Your Ref
Y/27/15/L
Our Ref
PLAN-009346
Date
09/04/2015

Proposal: Application for listed building consent for 1 No. annexe building providing ancillary accommodation to main house.

Site: The Old Thatched Cottage, North End Road, Yapton, BN18 0DL.
Y/27/15/L

Southern Water MapGuide Browser

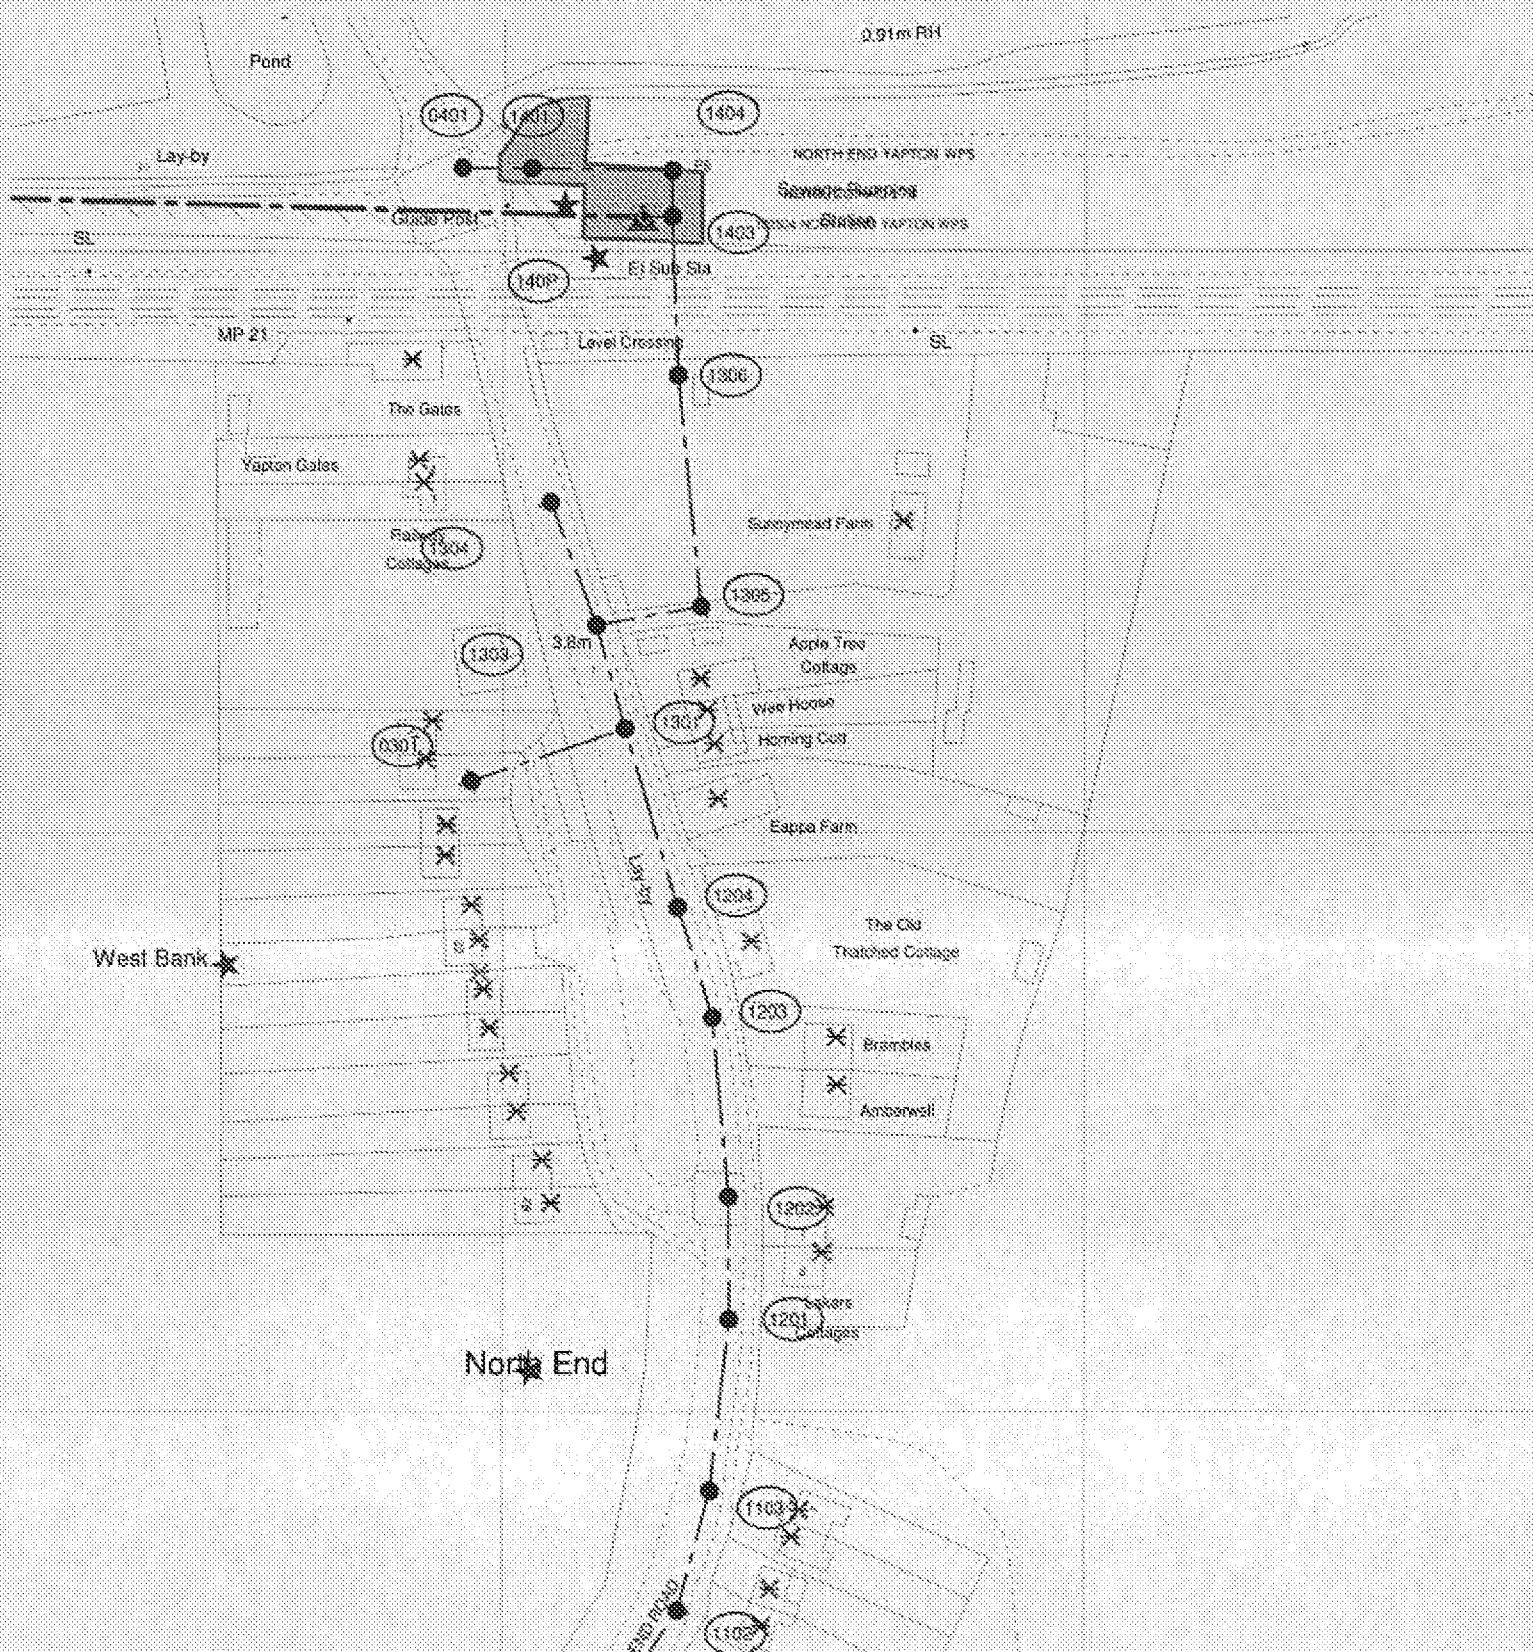
Our initial investigations indicate that there are no public surface water sewers in the area to serve this development. Alternative means of draining surface water from this development are required. This should not involve disposal to a public foul sewer.

Due to changes in legislation that came in to force on 1st October 2011 regarding the future ownership of sewers it is possible that a sewer now deemed to be public could be crossing the above property. Therefore, should any sewer be found during

construction works, an investigation of the sewer will be required to ascertain its condition, the number of properties served, and potential means of access before any further works commence on site. The applicant is advised to discuss the matter further with Southern Water, Sparrowgrove House, Sparrowgrove, Otterbourne, Hampshire SO21 2SW (Tel: 0330 303 0119) or www.southernwater.co.uk".
